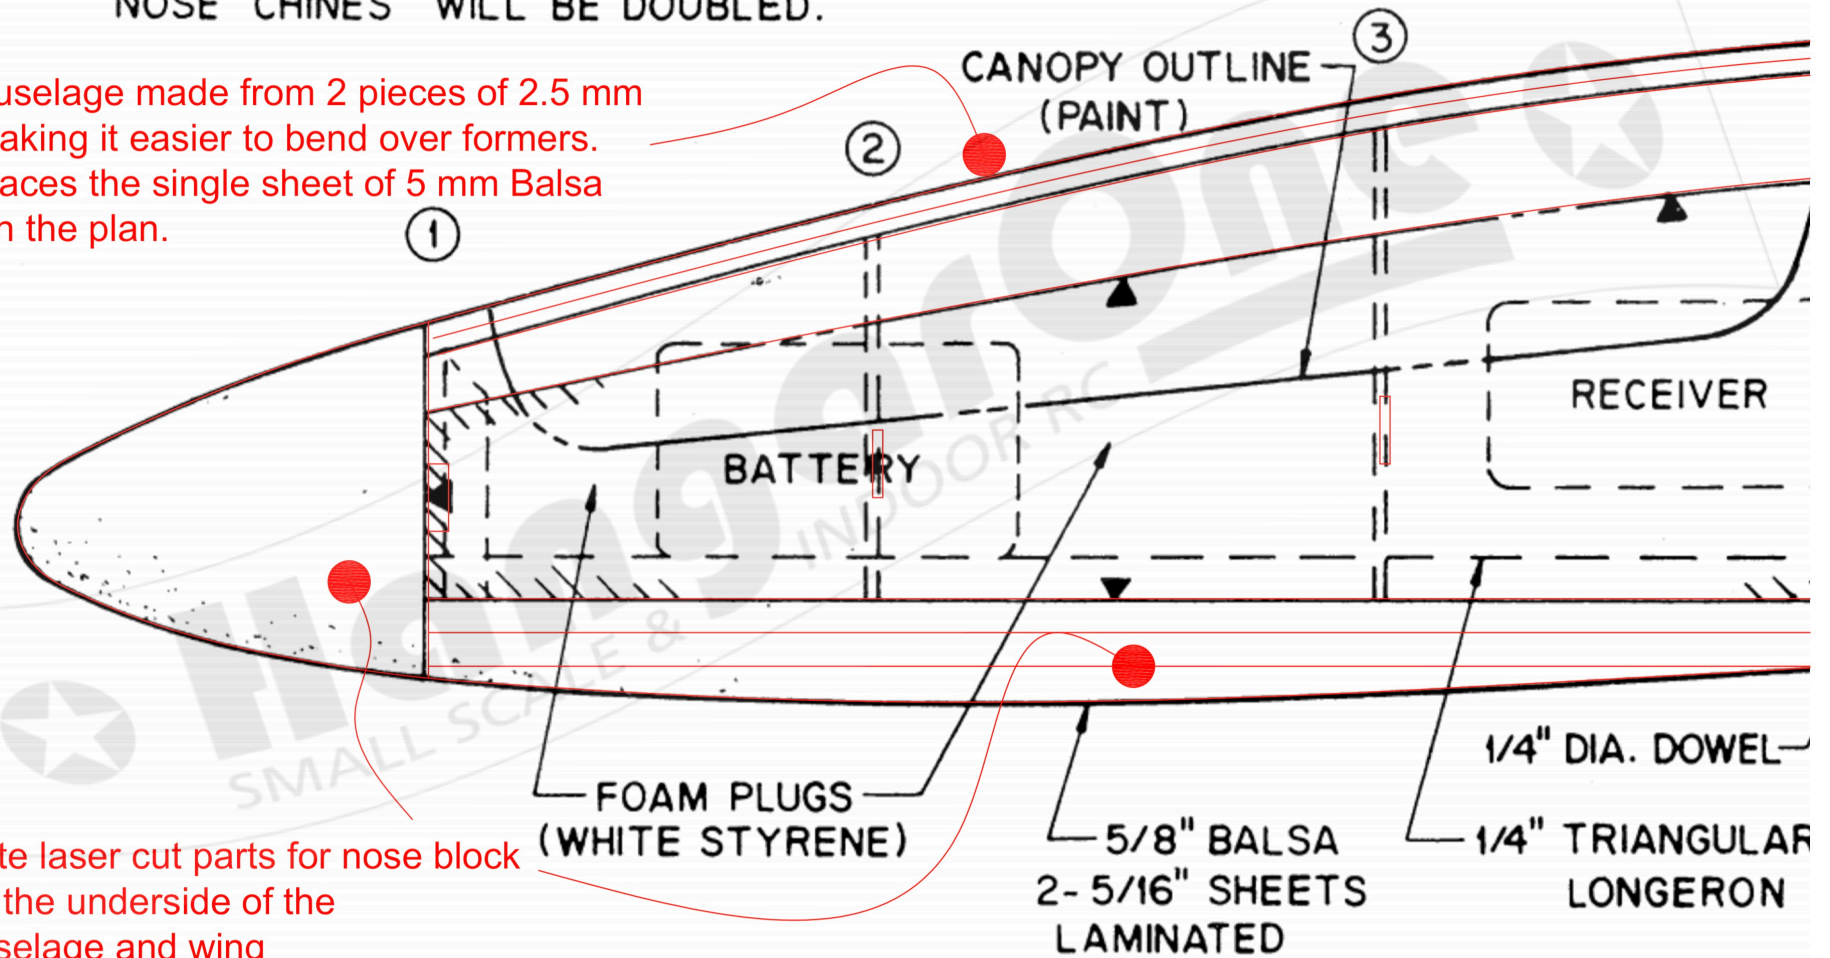
SHOWN ON SIDE VIEW. OVERLAP SO
NOSE "CHINES" WILL BE DOUBLED.

Top of fuselage made from 2 pieces of 2.5 mm
Balsa making it easier to bend over formers.
This replaces the single sheet of 5 mm Balsa
shown on the plan.

Laminate laser cut parts for nose block
and for the underside of the
front fuselage and wing
